Work Order ID 70924

Item Name: Basket Hoop

DESIGN #	DRAWN BY CP	DART AEROSPACE LTD HAWKESBURY, ONTARIO, CANADA	
CHECKED #	APPROVED #	DRAWING NO. D3166	REV. A SHEET 1 OF 1
DATE 02.07.10		TITLE BASKET HOOP	SCALE NTS
A	02.07.10	NEW ISSUE	
A1	04.04.08	38+/-1 WAS 36.0

DRAWING NO. D3166	TITLE BASKET HOOP	REV A1	DART AEROSPACE LTD ENGINEERING ORDER		D.E.O. NO. D3166-A-2	SHEET NO. 1 OF 1	SCALE NTS
DRAWN AJS	CHECKED <i>[Signature]</i>	MFG. APPR. <i>[Signature]</i>	APPROVED <i>[Signature]</i>		DE APPR. <i>[Signature]</i>		
DATE 08.12.11	DATE 08.12.15	DATE 08/12/15	DATE 08/12/16		DATE 08.12.16

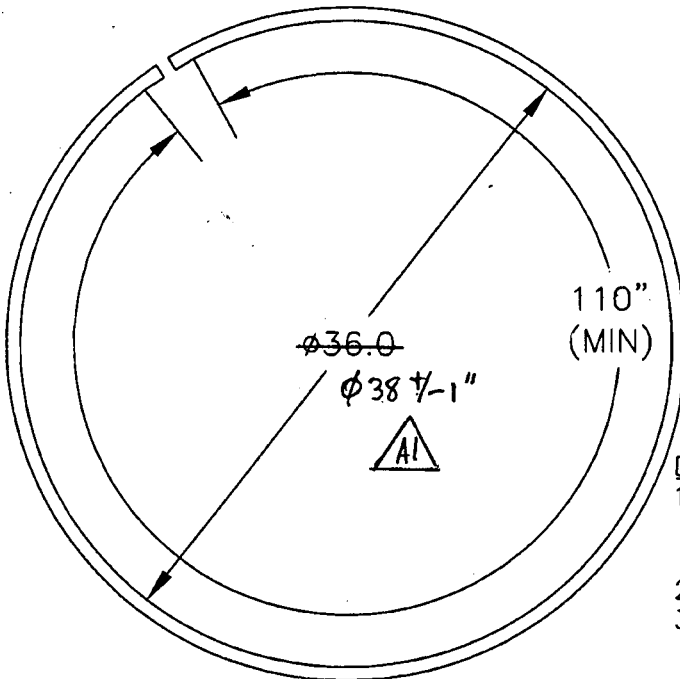
1) MODIFY MATERIAL NOTE FOR D3166-1 AS SHOWN:

2) MODIFY MATERIAL NOTE FOR D3166-3 AS SHOWN:

REASON: SEE PAR 08-005

IS:

- 1) MATERIAL: AISI 304/316 SS, 3/4 X 3/4 X 0.065 WALL SQUARE TUBING,
60.00" LONG
REF. DART SPEC M304TS0.750W.065

IS:

- 1) MATERIAL: AISI 304/316 SS, 3/4 X 3/4 X 0.065 WALL SQUARE TUBING,
120.00" LONG
REF. DART SPEC M304TS0.750W.065
